1 Courtyard North Elevation - Planning Scale 1:200

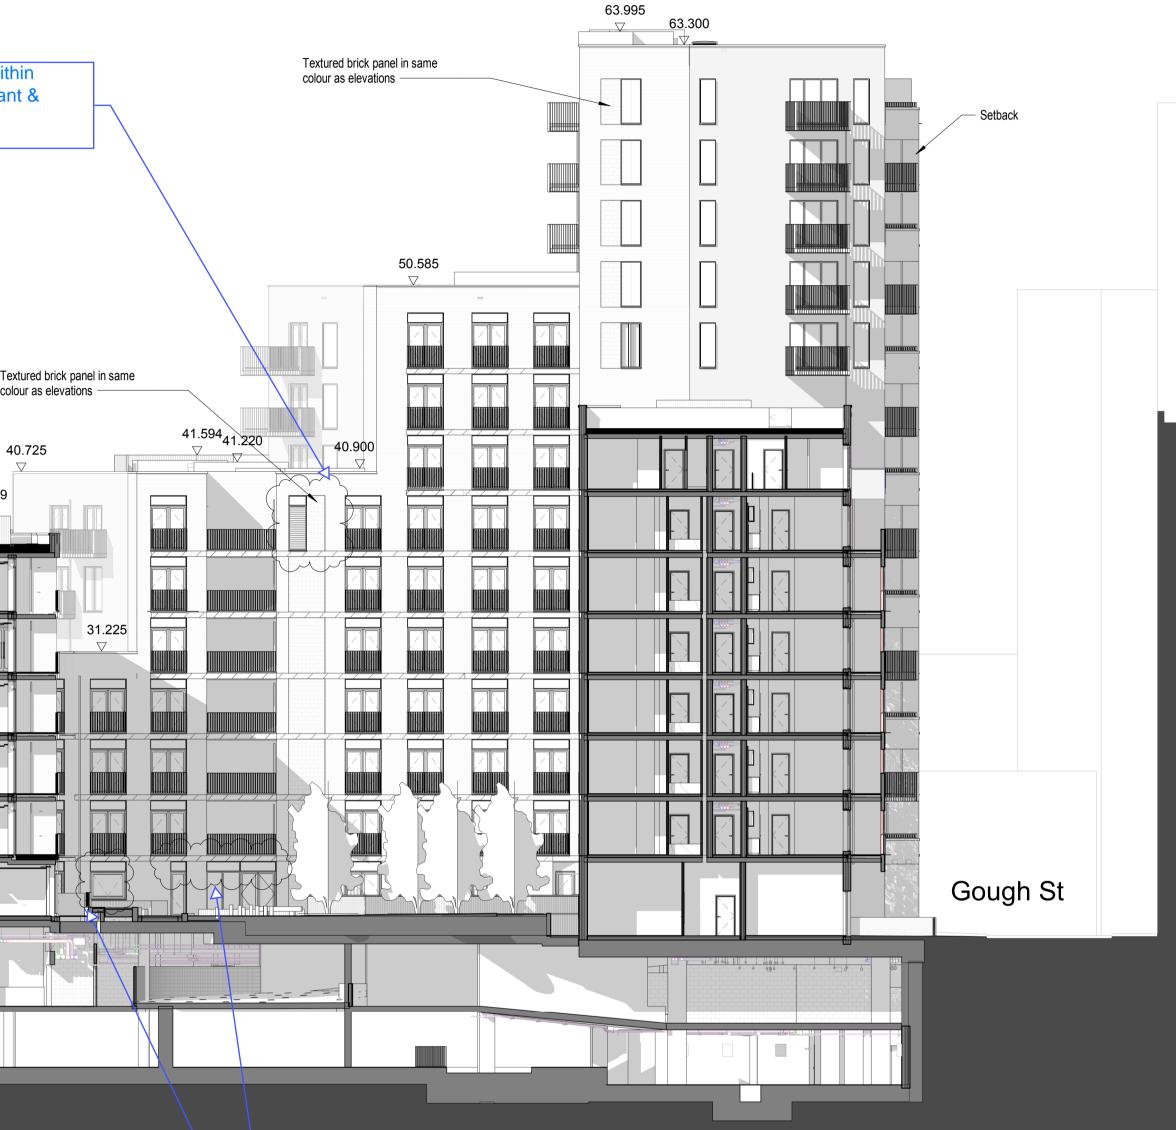
Louvred ventilation spandrel panels introduced to window design to allow ventilation of both Upper Ground Gym and Lower Ground Cinema.

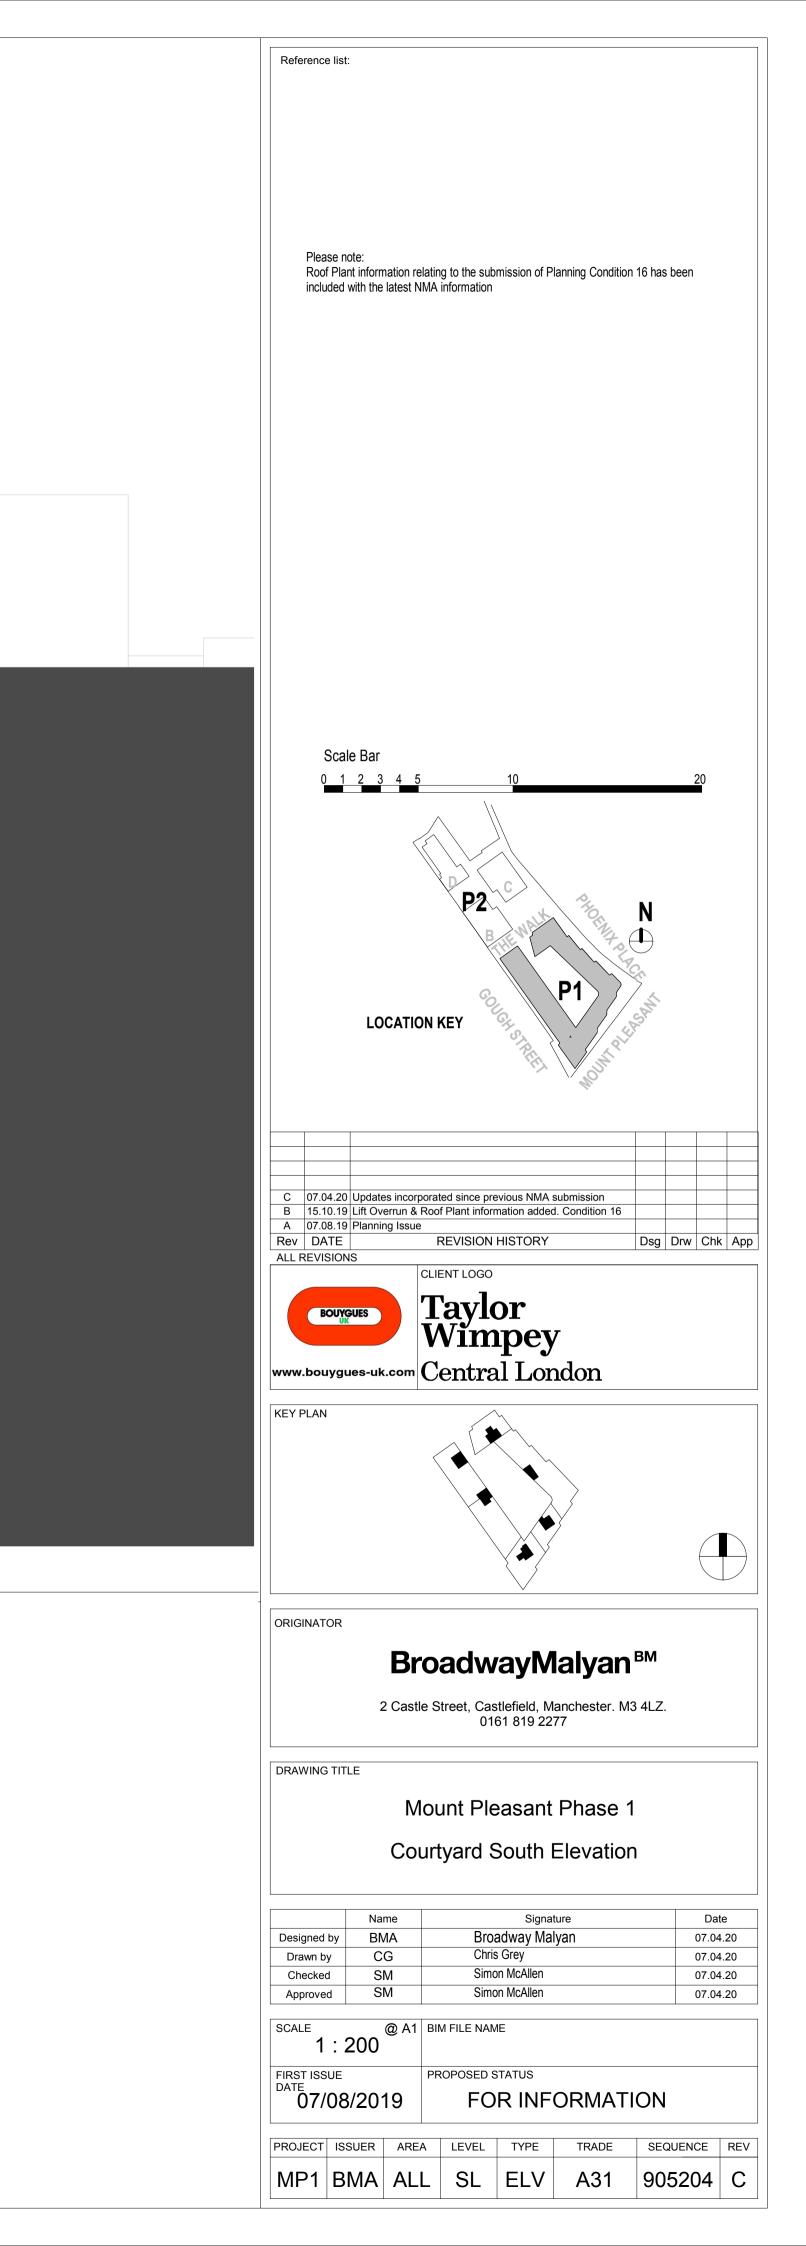
Louvred ventilation spandrels above door / windows removed and blank colour matched spandrels reinstated. 1 no. window replaced with lookalike bottom hinged AOV. lease refer to section 3.4.21 and Fig 22 of FDS Fire Strategy Report Rev F.

RMG Staircore entrance removed on Gough Street Elevation. Door width updated to reflect 1100mm clear width requirement as shown in section 3.10.4 of FDS Fire Report Strategy Rev F.

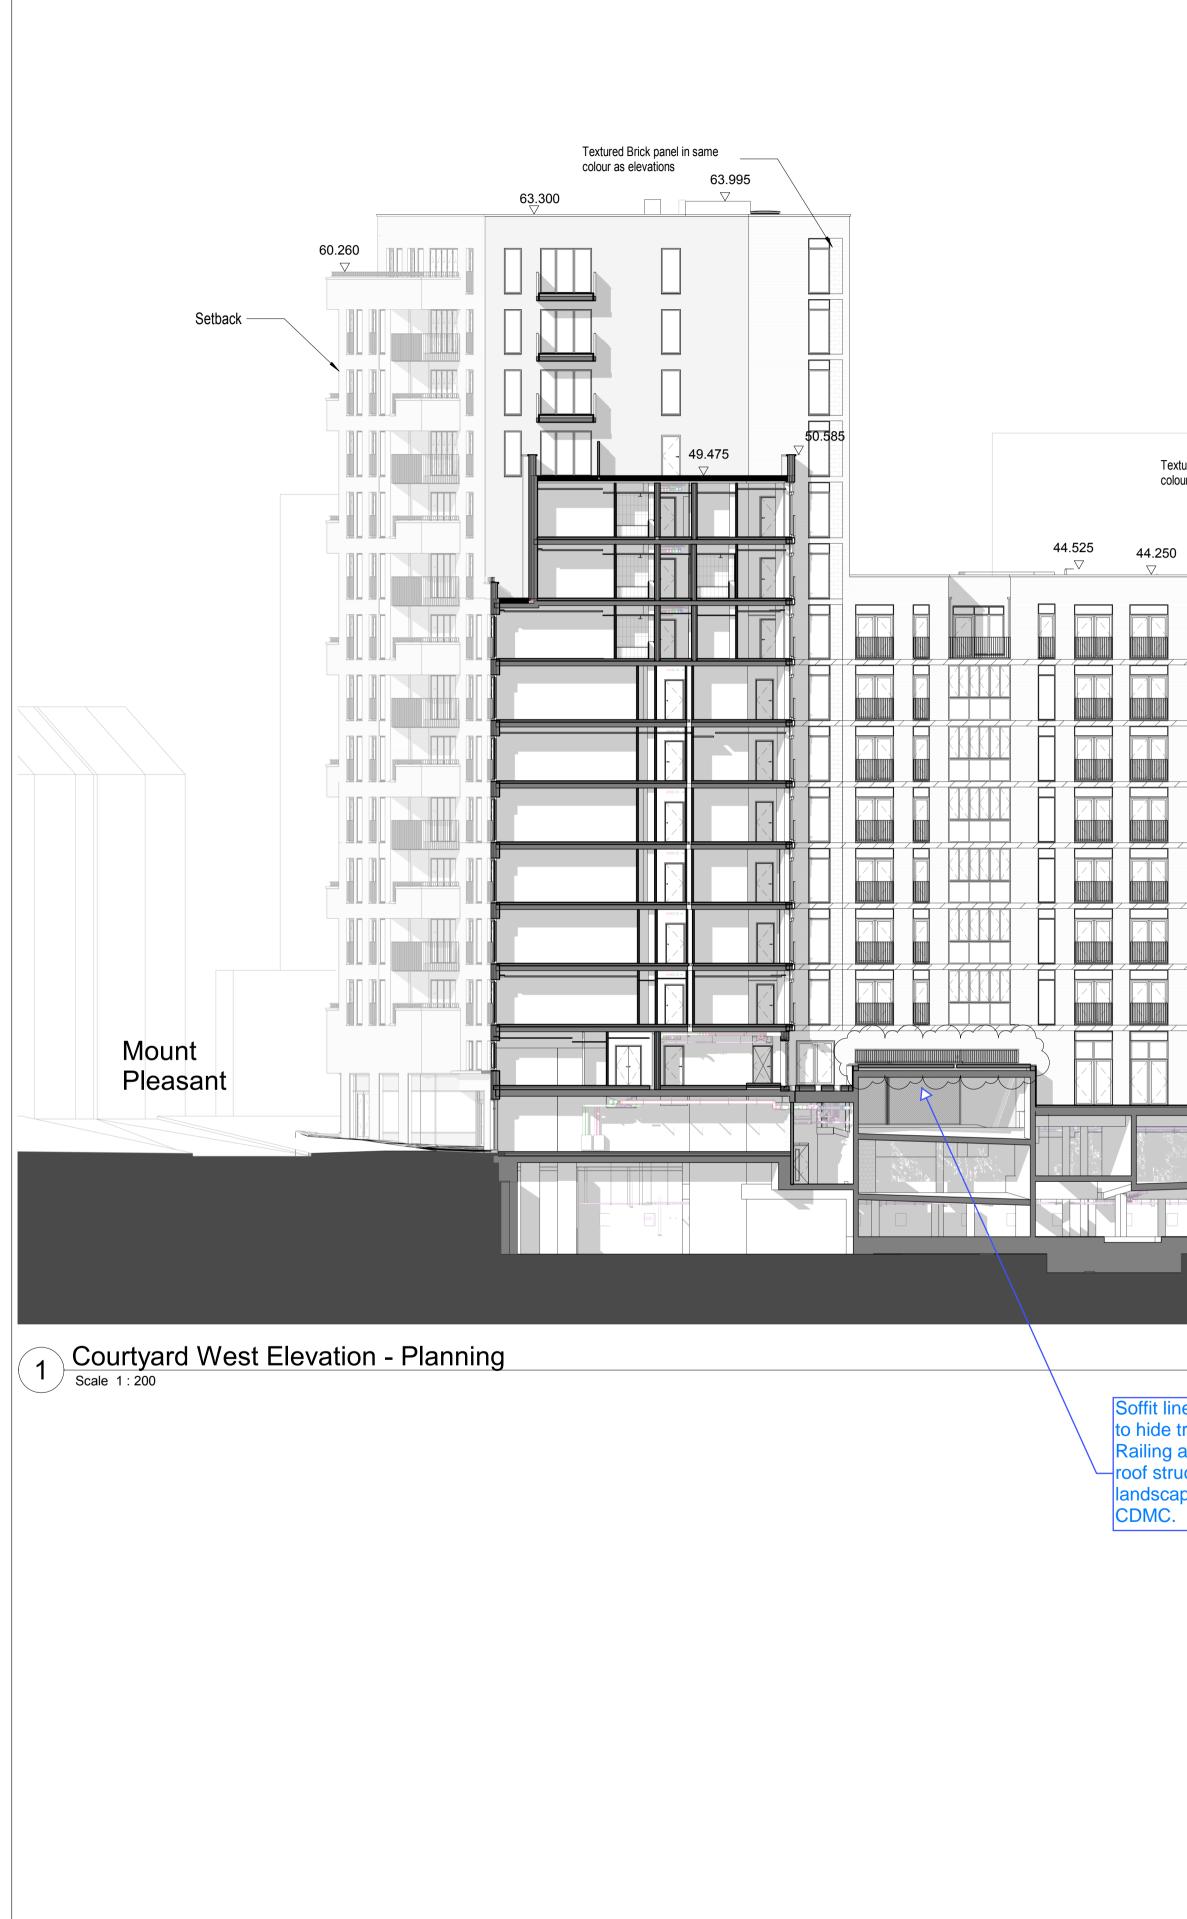
Soffit line lowered to Ramp area on Gough Street Elevation in order to hide transfer slab

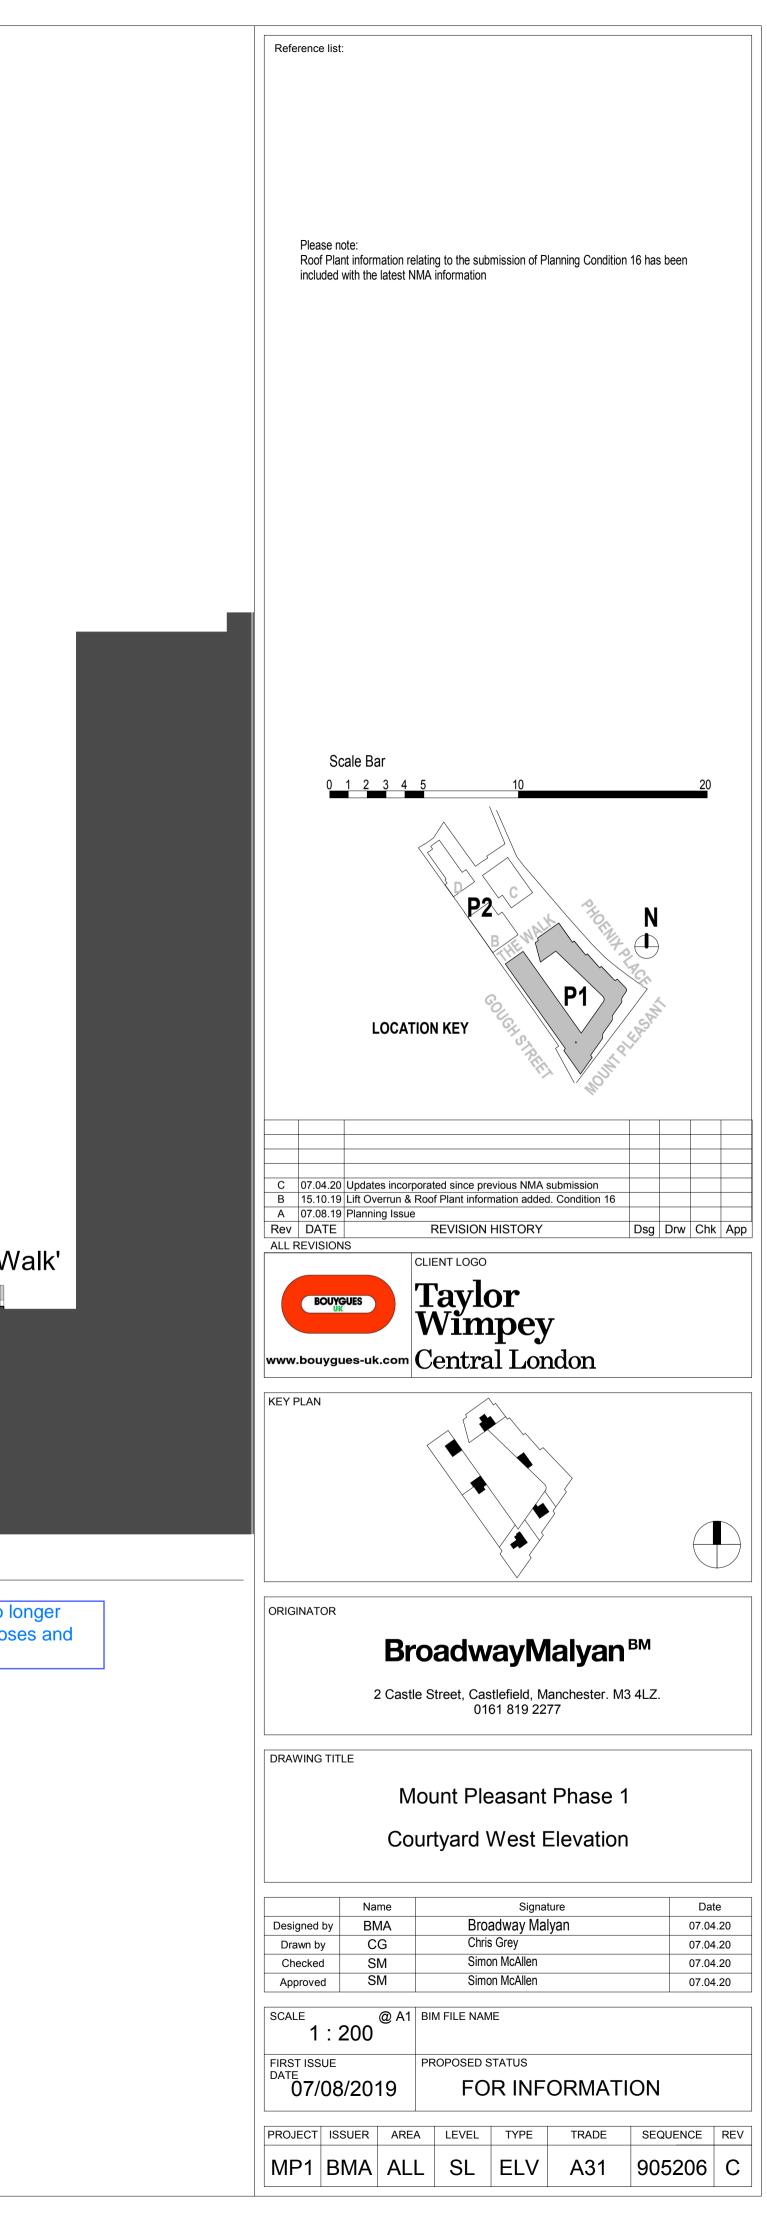
to hide transfer slab. Bronze PPC Steel Railing added to edge of Car Park ramp roof structure to prevent falls from the landscape above, as requested by CDMC. Entrance door updated to reflect intended door design. Louvred ventilation spandrel panel above door no longer required for ventilation purposes and therefore replaced with subdivided spandrel panel to suit elevation Louvred ventilation panel no longer required for ventilation purposes and therefore removed

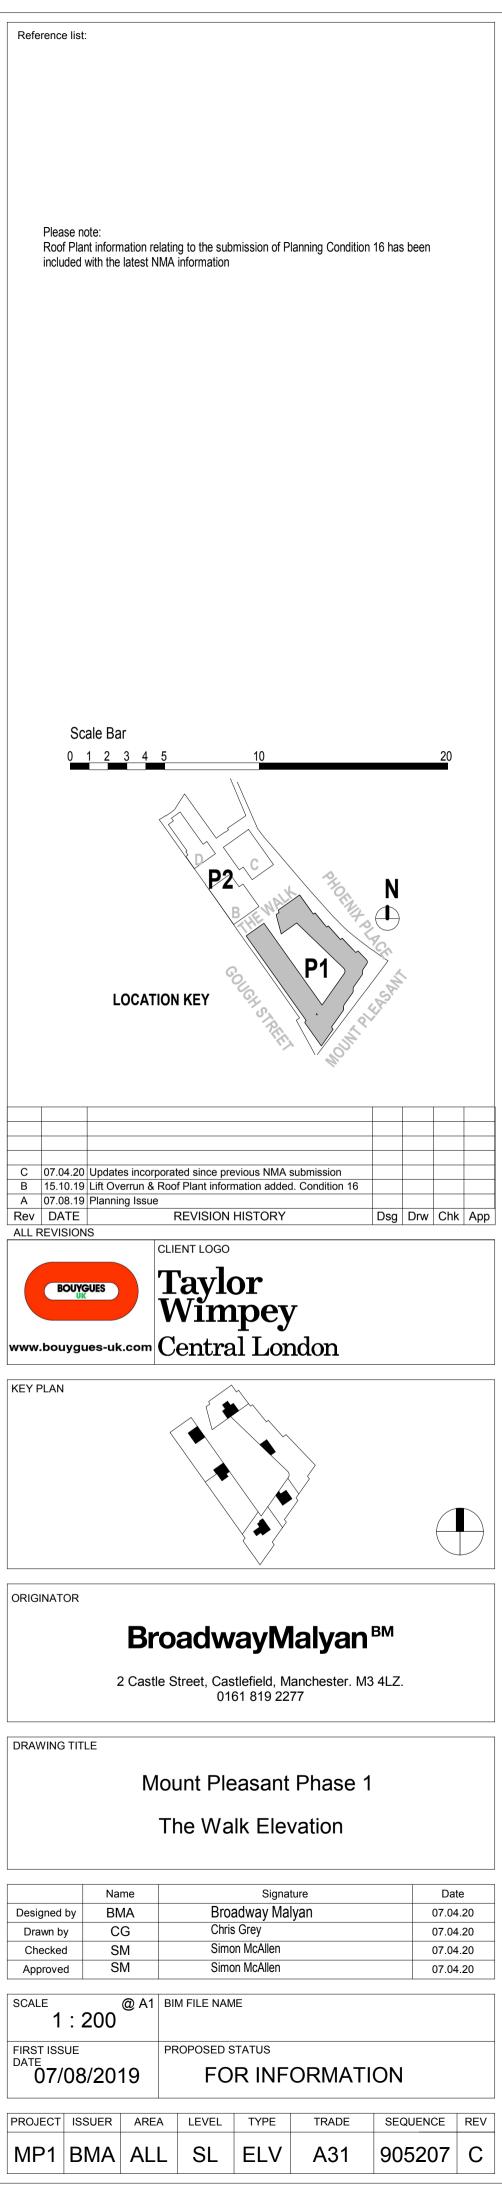
Spandrel panel above Fire Escape Exit door replaced with AOV in order to vent – Lobby to designed escape route as shown on *Fig. 28 of FDS Fire Strategy Report Rev F.* Door width adjusted to allow for requirement of 1100mm clear width as per section 3.10.4 of FDS Fire *Strategy Report Rev F.*

Spandrel panel above Fire Escape Exit door replaced with AOV to vent the basement & lower ground floor staircase, as shown in *fig. 28 of FDS Fire Strategy Report Rev F.* Door width adjusted to allow for requirement of 1100mm clear width as per section 3.10.4 of FDS Fire *Strategy Report Rev F.*
